**Outparcel Building Wellington Town Square** **STAFF REPORT**

**Petition Number:** 2026-0019-ARB

**Request:** Architectural Review Board approval of the exterior colors and wall signage for an outparcel building within the Wellington Town Square project.

**ARCHITECTURAL REVIEW BOARD**

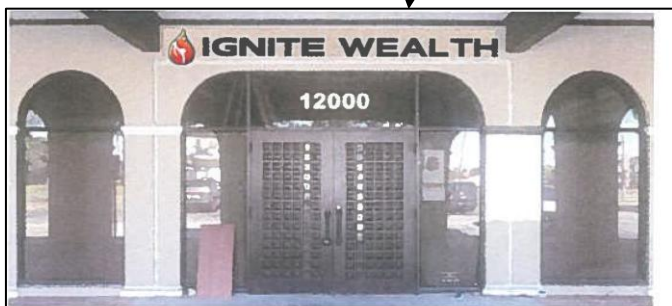
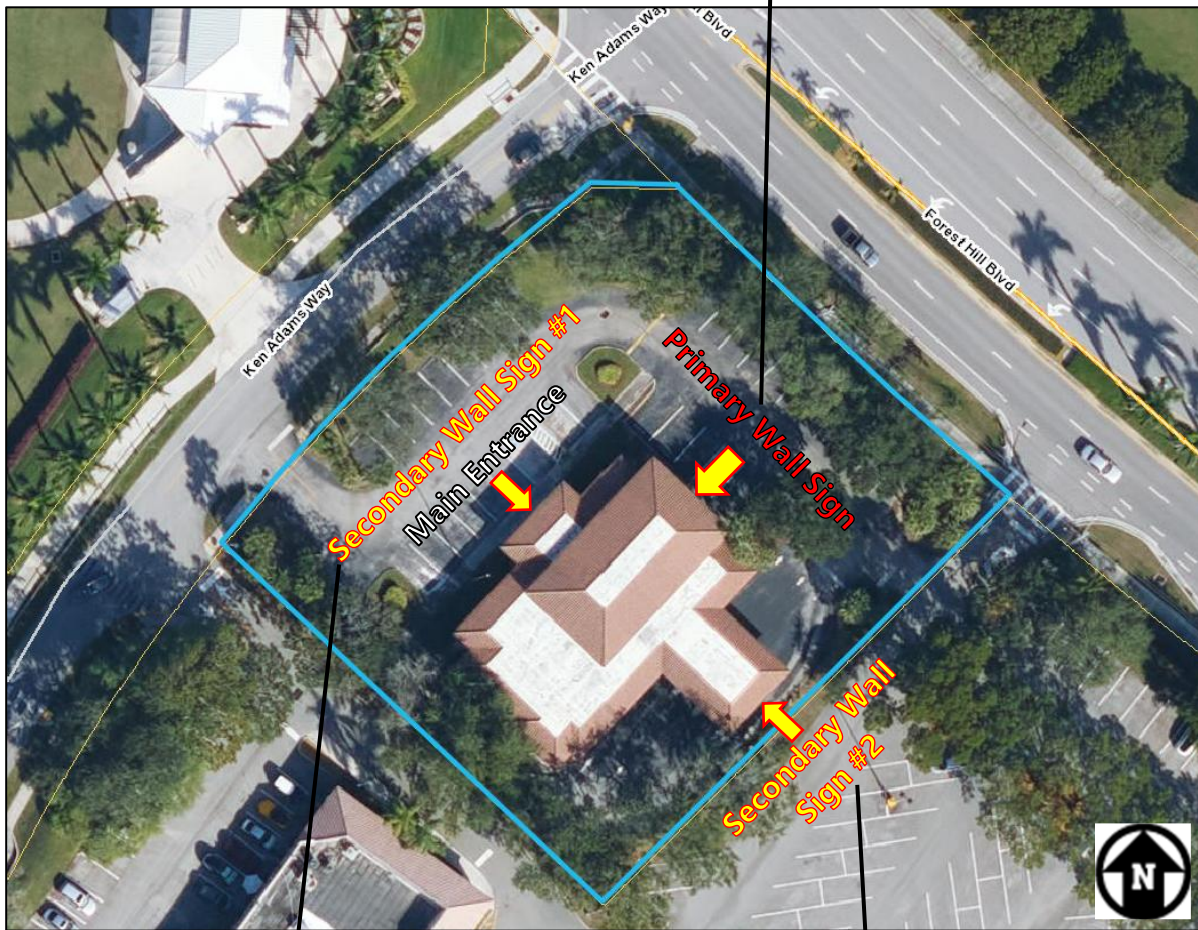
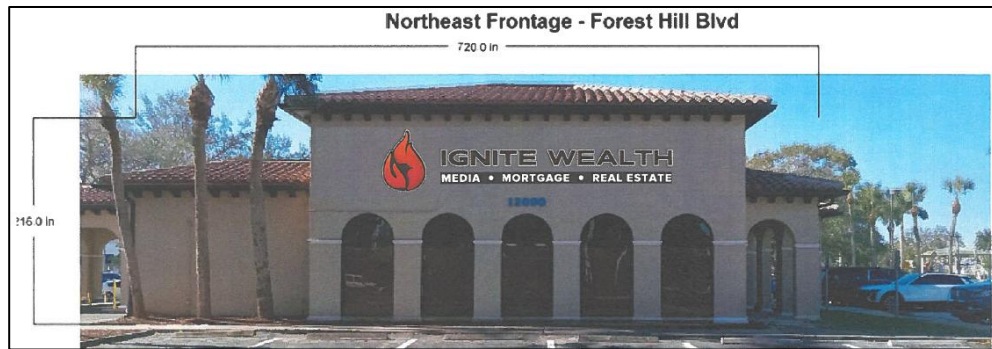
As stated, the building was painted without prior approval, and the applicant is requesting ARB approval. The subject building exterior white wall paint color is consistent with the surrounding main in-line building (Public, Provident Jewelers, etc.) off-white color, is compatible with the existing CVS building neutral colors, and the brown trim/roof color is compatible with the surrounding areas/projects. The colors used are on the approved Wellington ARB Color Chart. Below are pictures of the painted building.

1. The exterior paint shall be a non-glossy finish consistent with the color palette/scheme in Exhibit A, and as approved below:
  - a. The dumpster enclosure fence shall be painted with the brown/bronze color (BRZ6 Medium Bronze) within 30 days of this approval.

- b. Utility box, conduit, vents, etc., shall be painted the same color as the area/surface it is attached to/surrounded, as approved by Wellington.
  - c. All window/door/storefront glass glazing color shall be clear (no color) or bronze tint (max. 50% opacity). The window/door/storefront frames shall be finished in the bronze color or the surrounding wall color.

- d. The approved color palette/scheme shall not be substituted for any other option (including future repainting) without ARB approval.
2. All visible exterior lighting shall be illuminated with white light.

Scale: 3/16" = 1'

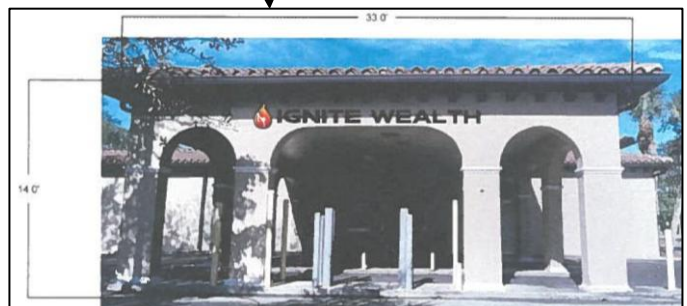
As illustrated above, the applicant is requesting to have their primary wall sign on the northeast façade, which does not have a main entrance, and allow the secondary wall signs on the northwest façade (Secondary Sign #1), which has the main entrance, and the southeast/back façade (Secondary Sign #2). Below is what’s allowed per the LDR, being requested, and deviations for the wall signs.

As stated above, the requested deviation is to allow the proposed primary wall sign on the northeast façade that does not have a main entrance, and to allow the secondary wall sign on the northwest façade (Secondary Sign #1) with the main entrance. Also, the applicant is requesting the proposed primary wall sign height at 60 inches, instead of the allowed 30 inches.

The requested deviations will allow the proposed primary wall sign on the northeast façade, which has wall area to accommodate signage. If the primary wall sign is on the northwest façade with the main entrance, it would limit the size permitted for the secondary signs on the other façades.

Allowing the primary wall sign on the northeast façade will ensure the sign is proportional to the area of the building to which it is attached and help to enhance the building's aesthetic. Also, the northeast façade has frontage along Forest Hill Boulevard, which will allow the primary wall sign to provide additional visibility to the adjacent traffic.

3. The wall signs shall be consistent with Exhibit B, and as approved below:
  - a. All sign design shall be channel letters (Finished Matte Black or White), with supports, components, etc., remotely housed, and raceway painted to match the attached wall area.

- b. All signs shall be illuminated with white light, except the “Flame” logo may be illuminated with backlit red light.
  - c. Signs shall be consistent with the below approved maximum standards and shall be an appropriate scale for the attached area on the building, or may require modification to the standards (below the approved maximum) during the permitting process for each sign request, as approved by the project’s Wellington Development Review Manager (DM). The deviations are approved with the condition that all the wall signs will be per these approved standards (which may be in addition to what is allowed by the LDR), and modifications above the approval will require ARB approval.

<b>Principal Wall Sign <sup>1</sup> (Northeast Façade/Elevation)</b>		
Standards	Approved	Deviation
Number of Signs	1	0
Sign Area	120 sq. ft.	0
Height	60 in. (Logo)/16 in. (Text)	30 in.
Length	20 ft.	0
<b>Secondary Wall Signs</b>		
<b>No. 1 – Northwest Façade/Elevation (Main Entrance)</b>		
Standards	Approved	Deviation
Number of Signs	1	0
Sign Area	5.7 sq. ft.	0
Height	8.62 in.	0
Length	7.9 ft.	0
<b>No. 2 – Southeast Façade/Elevation (Drive-thru Canopy)</b>		
Standards	Approved	Deviation
Number of Signs	1	0
Sign Area	17.9 sq. ft.	0
Height	15 in.	0
Length	14.3 ft.	0
